SEQUIM-DUNGENESS WAY & WOODCOCK ROAD ROUND-ABOUT, CRP# C1257

ADDENDUM NO. ONE (1)

PAVING AND GRADING PLAN

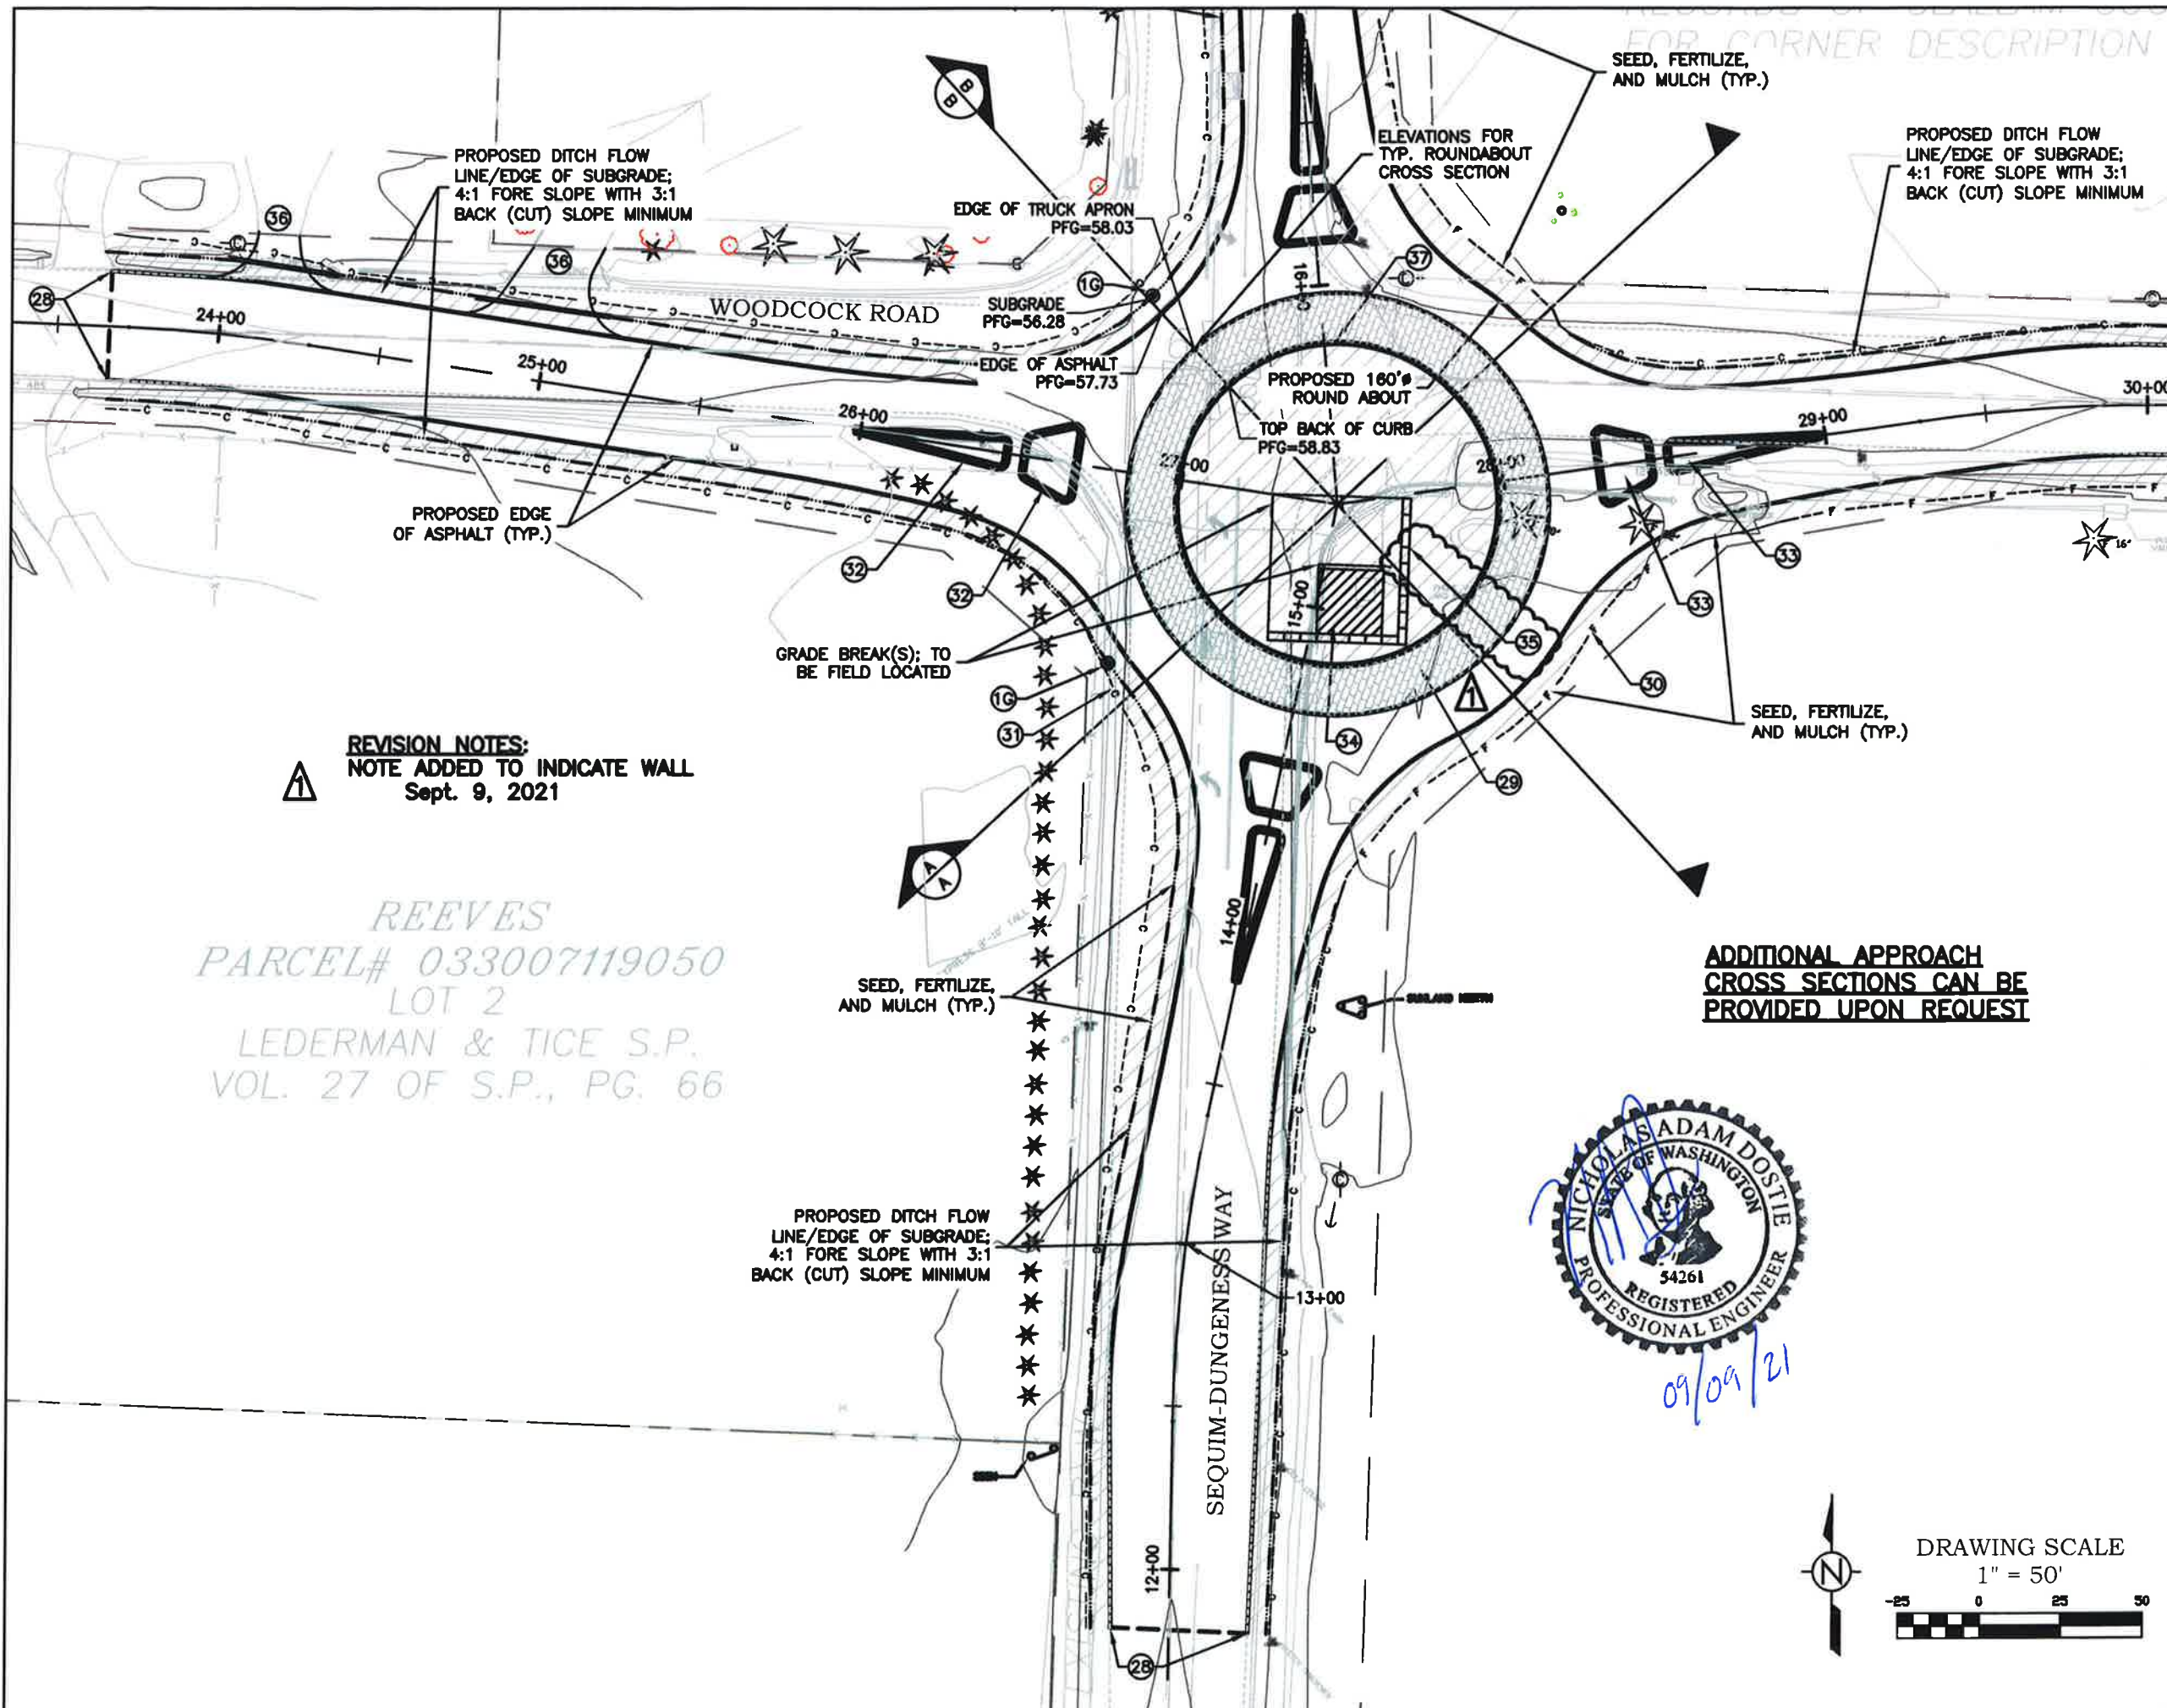
Due to a drafting error, note 35 was added to sheets 10 and 11 of the bid set plan. Remove the original bid set sheets 10 and 11, and replace with the provided revised sheets.

- 34 20'X20' CENTURY LINK/LUMEN EASEMENT TO BE PROTECTED; FINISHED GRADE OF 400SF AREA TO BE 56.4±
- 35 LOCK BLACK/ULTRA BLOCK RETAINING WALL WITH FLAT CAP; TOP OF WALL TO BE FLUSH WITH ADJACENT GRADE (58.83) WITH UNIFORM SLOPE EXTENDING WEST AND NORTH TO TRANSITION TO 56.4±

SHEET 11 OF 17

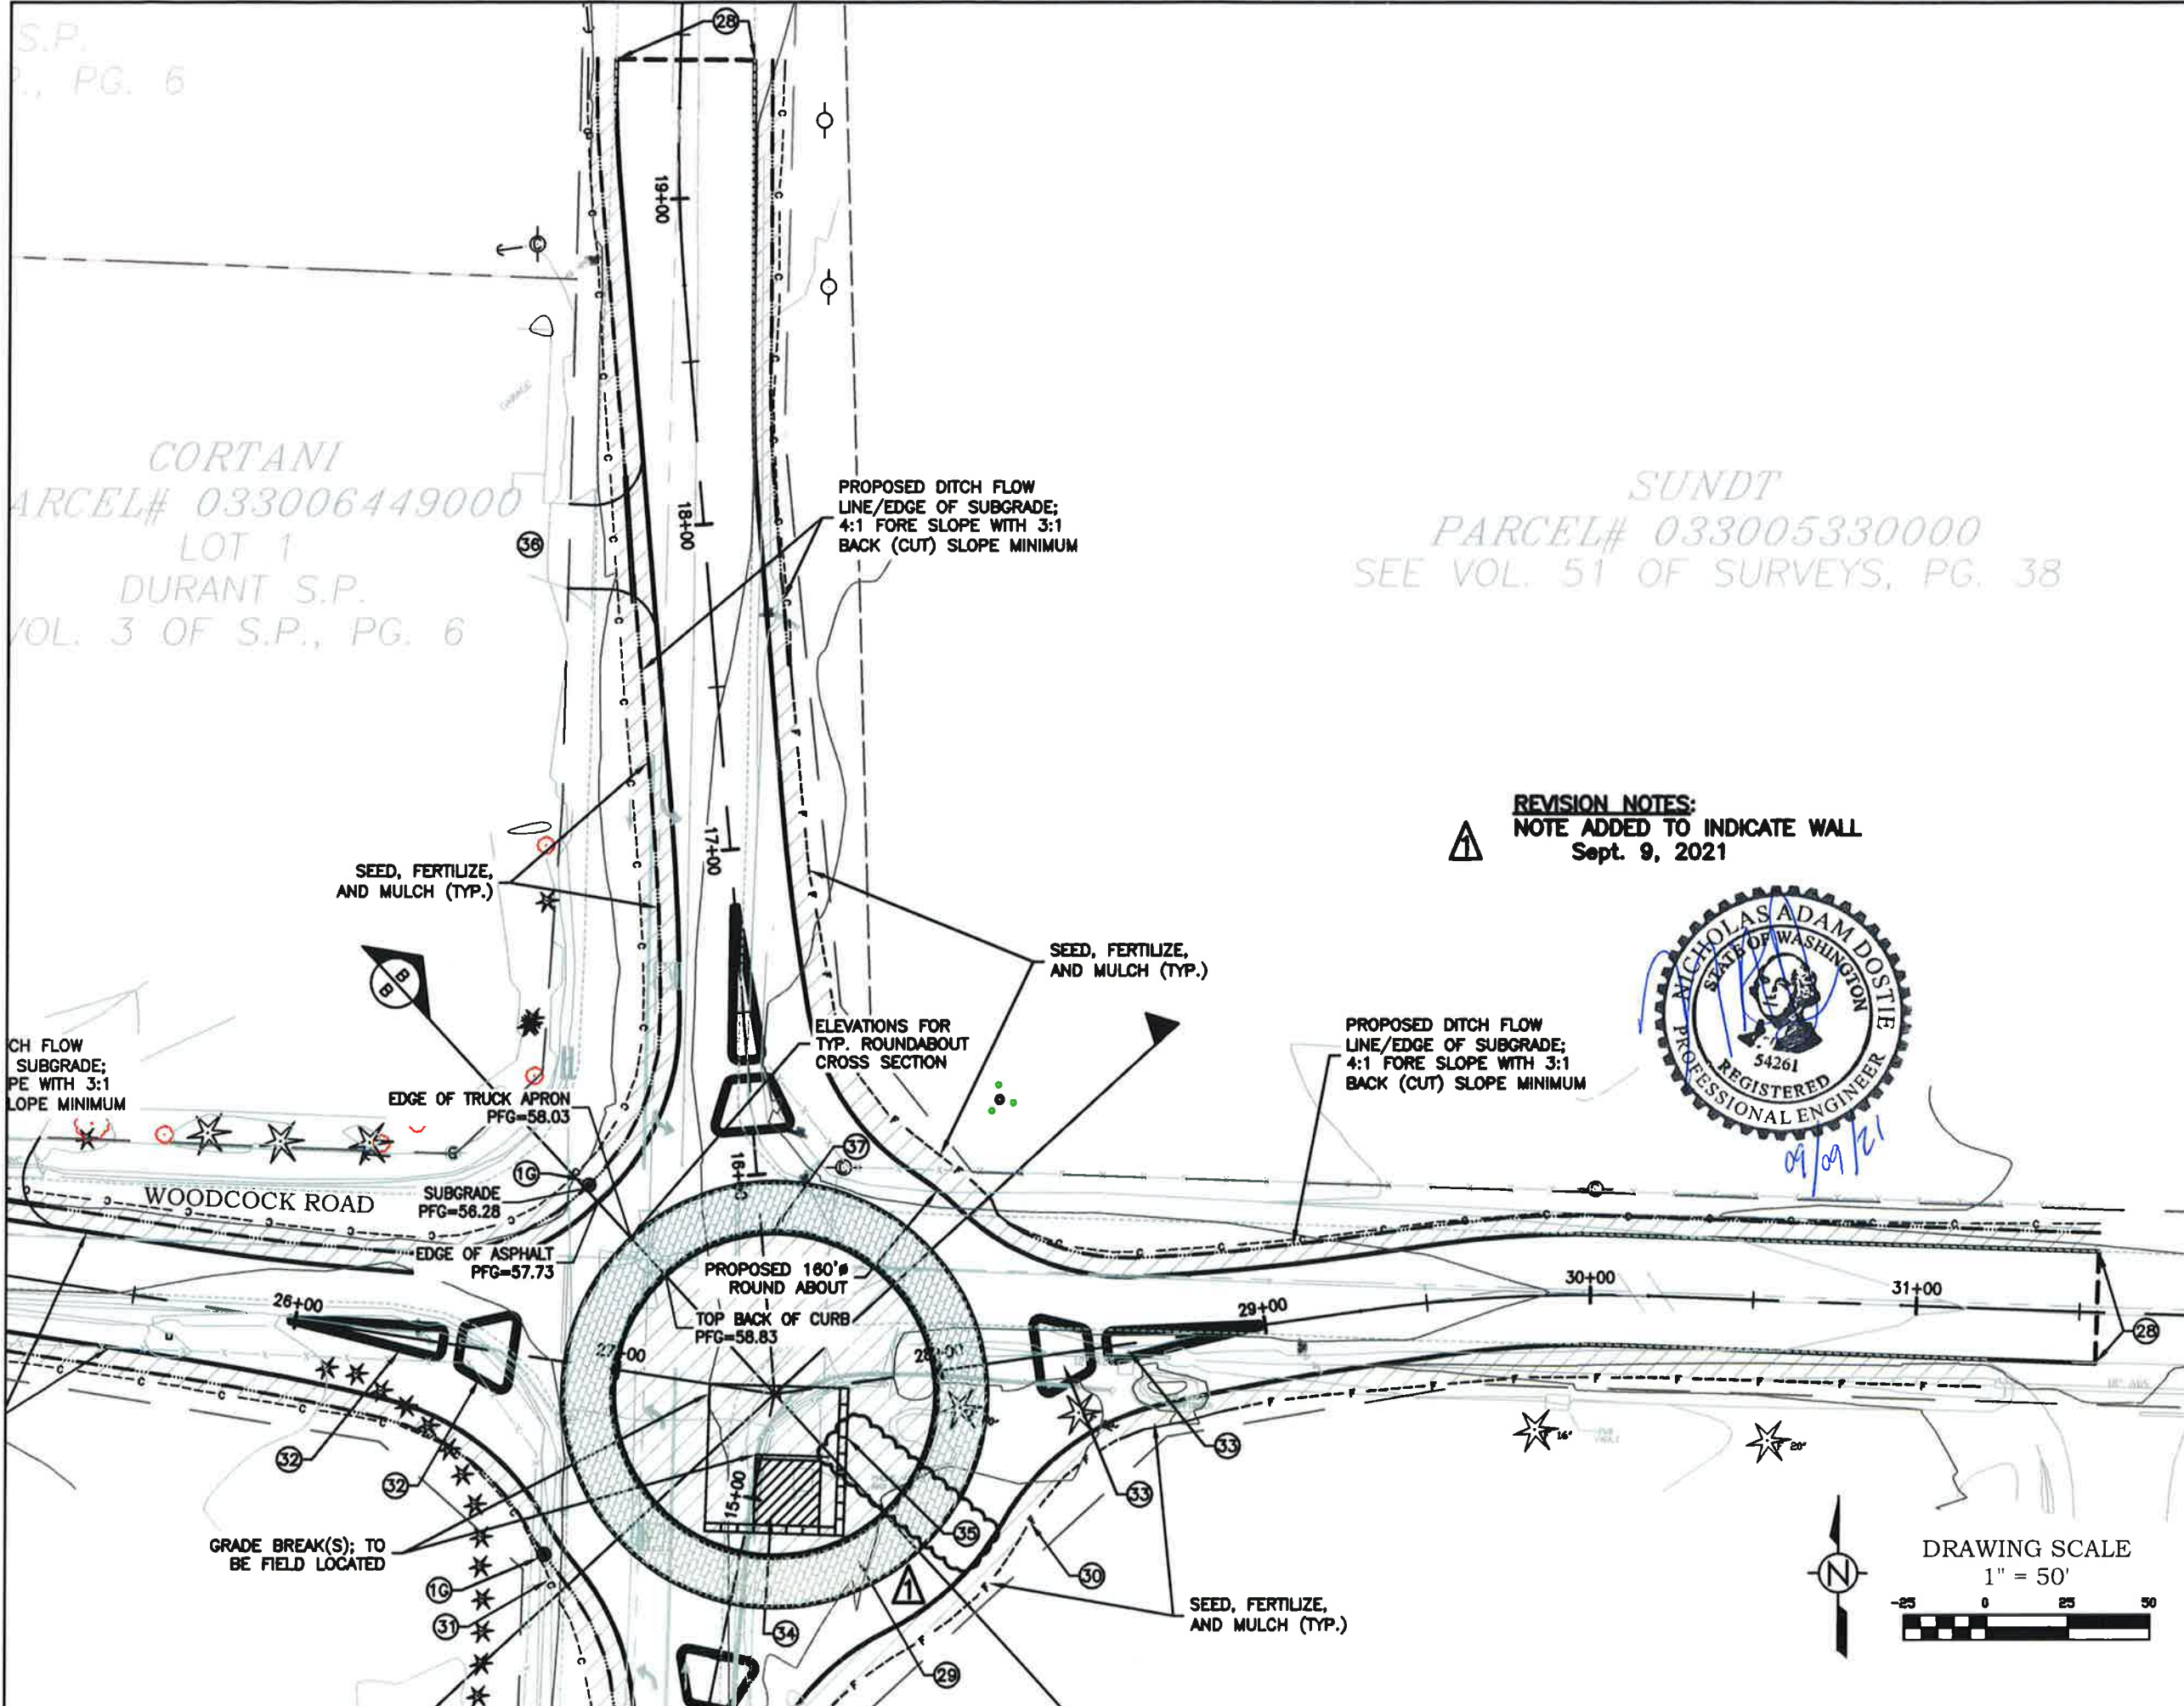
REVISION NOTES:
NOTE ADDED TO INDICATE WALL
Sept. 9, 2021

- 20'X20' CENTURY LINK/LUMEN EASEMENT TO BE PROTECTED; FINISHED GRADE OF 400SF AREA TO BE 56.4'±
- LOCK BLACK/ULTRA BLOCK RETAINING WALL WITH FLAT CAP; TOP OF WALL TO BE FLUSH WITH ADJACENT GRADE (58.83) WITH UNIFORM SLOPE EXTENDING WEST AND NORTH TO TRANSITION TO 56.4'±
